**NELSON GEOTECHNICAL
ASSOCIATES, INC.**

MEMORANDUM

RE: Intrachat Hoang Residence
7929 East Mercer Way
Mercer Island, Washington
NGA File No. 1276521

Geotechnical Peer Review Comment Response

Slope Stability Analysis - Cross Section A-A' Static Conditions

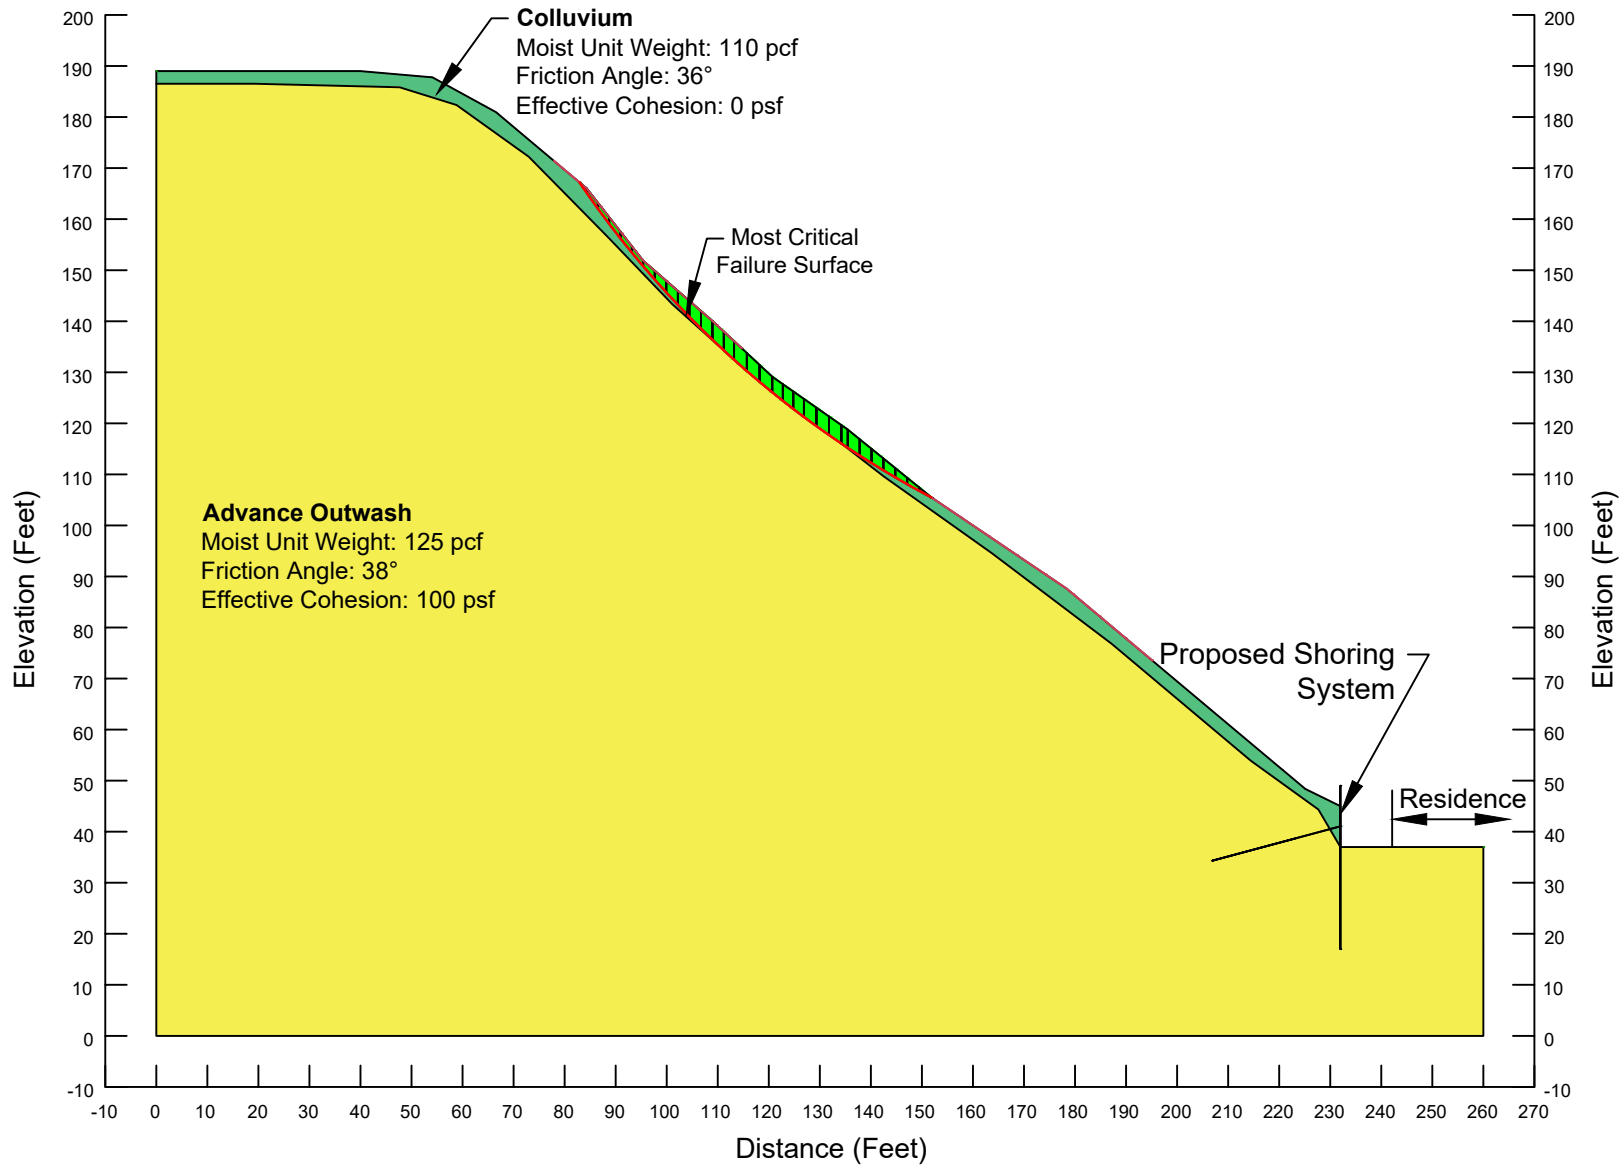
Comment 2: *In a report addendum, please provide static and seismic stability analyses of the slope uphill of the proposed residence. The geotechnical engineer indicated (page 7 of their report) that there is a significant potential for shallow sloughing or erosional events to occur during extreme weather conditions or seismic events. IBC also requires the use of MCE for the seismic slope stability analyses. If a pseudostatic analysis is conducted, provide an explanation (supporting documentation or references) of the seismic coefficient used in the analyses.*

Response 2: A limit equilibrium slope stability analysis was prepared along Cross-Section A-A', shown in our original report, utilizing the computer software Slope/W by GeoStudio. For seismic consideration, a pseudostatic coefficient of horizontal acceleration was applied to the model. Selection of a suitable pseudostatic coefficient was determined based on the FHWA document 11-032 (LRFD Seismic Analysis and Design of Transportation Geotechnical Features and Structural Foundations as well as the National Cooperative Highway Research Programs Seismic Analysis and Design of Retaining Walls, Buried Structures, Slopes, and Embankments, Report 611. These documents stipulate that the site-adjusted peak ground acceleration (PGA) is reduced due to the effects of wave scattering along slopes. The calculations for pseudostatic coefficient are shown in attached Figure 5 and yielded a pseudostatic coefficient of 0.13g, utilized in the slope stability analysis. Our site measurements and existing topographic information indicate the site slope extending above the residence is approximately 130 to 145 feet in height; however, the slope height was limited to 100 feet for the calculation, per the above reference documents.

The stability analyses indicated generally stable conditions under static and a likely shallow slope failure under seismic conditions. The corresponding factors of safety for static and seismic conditions for the most critical slip surface are 1.2 and 0.9, respectively. The results of the stability analyses are shown in **Figures 6 and 7.**

LIQUEFACTION ANALYSIS

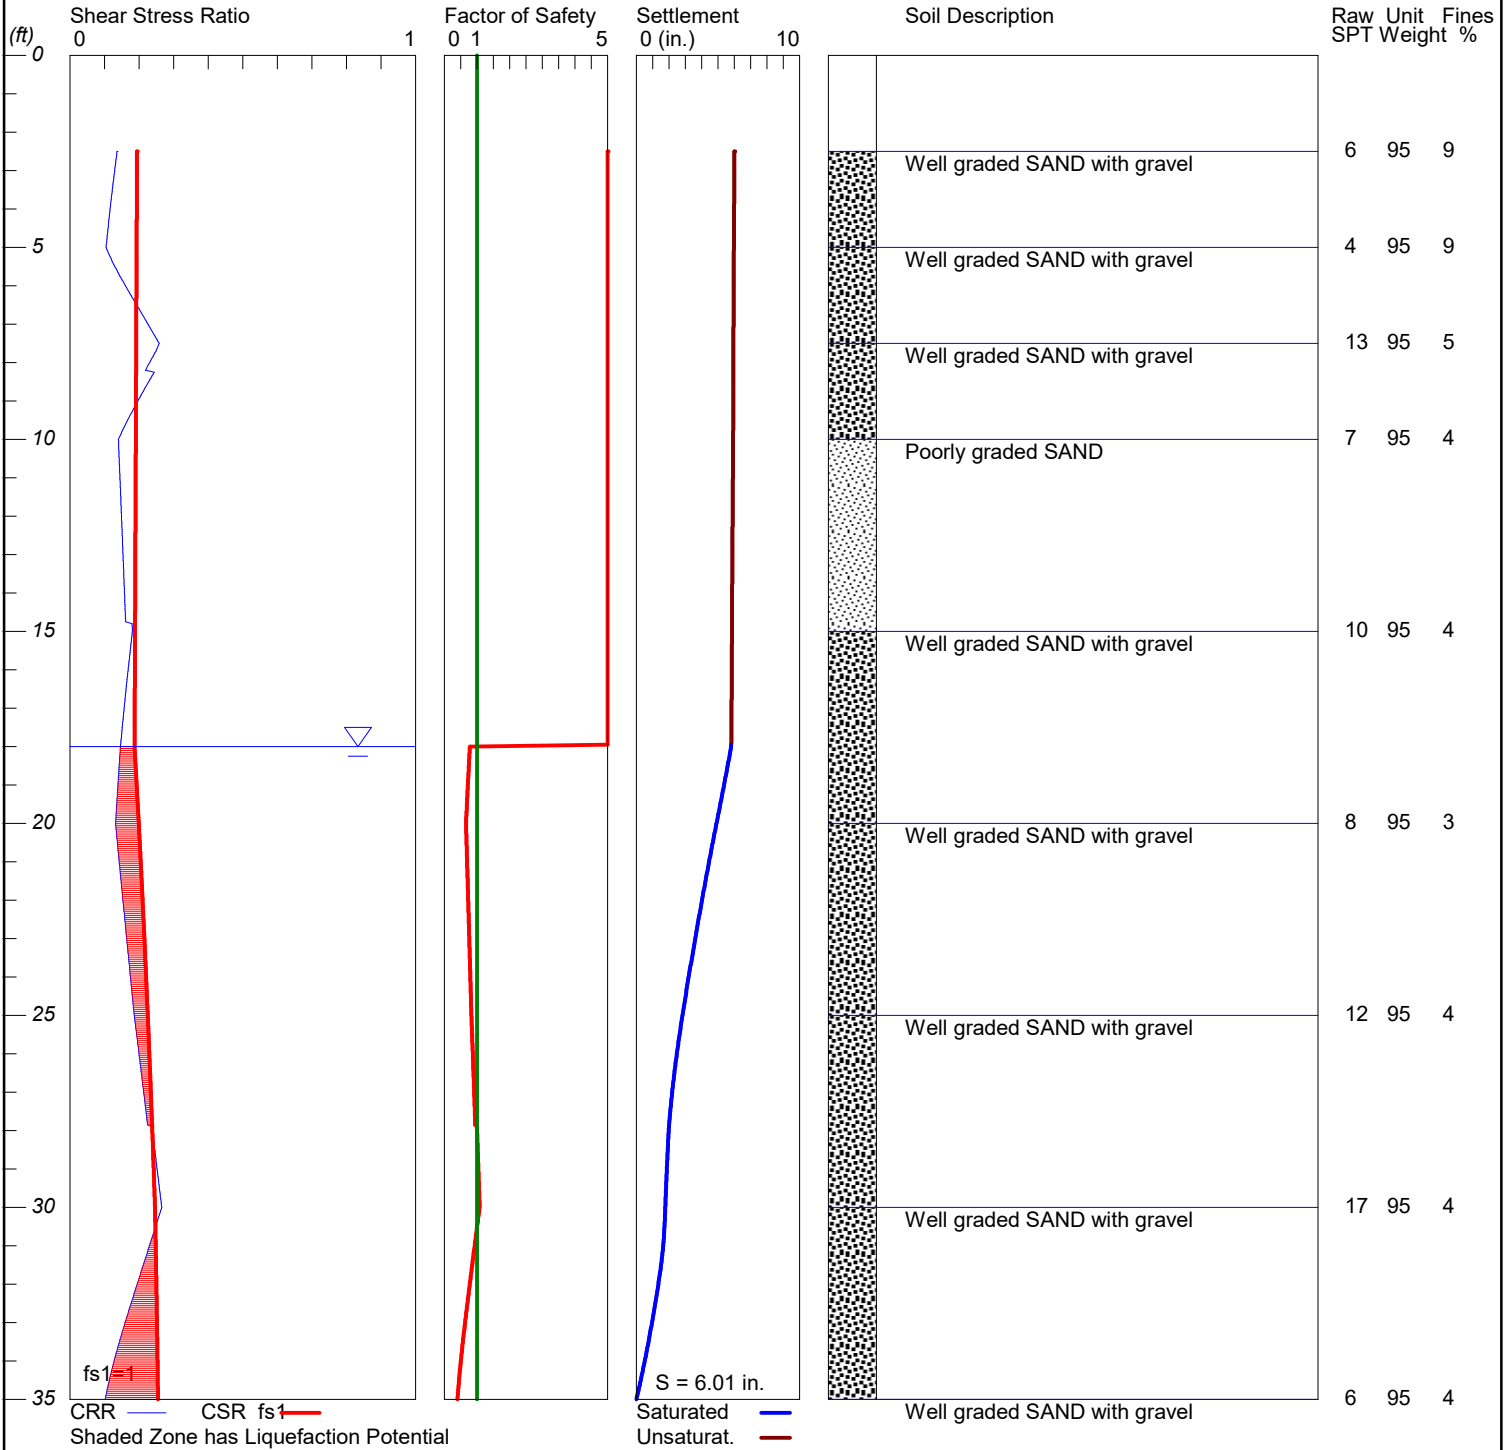
Comment 1: *The geotechnical engineer indicated in their report (page 5) that the onsite soils have a "moderate potential for liquefaction". Please determine the onsite soils' factor of safety against soil liquefaction. If liquefaction is anticipated under MCE earthquake ground motions, please provide an estimate of post-liquefaction settlement and analyze the potential for lateral soil movements (flow failure or lateral spreading). Please provide slope stability analyses results and supporting calculations for the estimated soil deformations in a report addendum.*

Response 1: The simplified liquefaction evaluation procedure outlined in FHWA-NHI-11-032 was utilized to determine the hazard potential based on subsurface data collected from the borings, review of nearby borings, and laboratory analyses. The procedure compares the cyclic resistance ratio to the cyclic stress ratio, induced by a design level earthquake. To aid in the analysis, we utilized the computer software Liquefy Pro by Civiltech. Inputs for the software include subsurface soil and groundwater properties, ground motion information, and drilling methods. The grain size analyses to support the design assumptions are attached to this memorandum as **Figures 1 through 4**. Along with the subsurface information collected by NGA, we also referenced a geotechnical boring performed by Cascade Geotechnical for the property located immediately southeast of the subject property (8011 East Mercer Way). Based on the above-referenced boring log, located at an approximate elevation correlating to the termination depth of B-2 performed on the subject site, the loose well-graded sand encountered beneath the site is expected to continue below the termination depth of B-2 an additional approximately 5-feet before transitioning to a cohesive silt/clay deposit. Therefore, the stratigraphy utilized in the liquefaction modeling includes a column of loose, well-graded sand extending 35-feet below the ground surface, where the groundwater surface was encountered at approximately 18-feet below the existing ground surface at the time of drilling. We did not consider the lower silt/clay unit in the analysis due to its likely high fines content and low liquefaction potential. An acceleration of 0.3g was utilized in the modeling and is reflective of a 50 percent reduction in the peak ground shaking, due to excess pore water pressure generation and subsequent soil stiffness softening. The results of the liquefaction analysis are attached on **Plate A-1**. The analysis indicates a total liquefaction-induced soil settlement of approximately 6-inches, where factors of safety for liquefaction primarily drop below one, below the observed groundwater elevation.
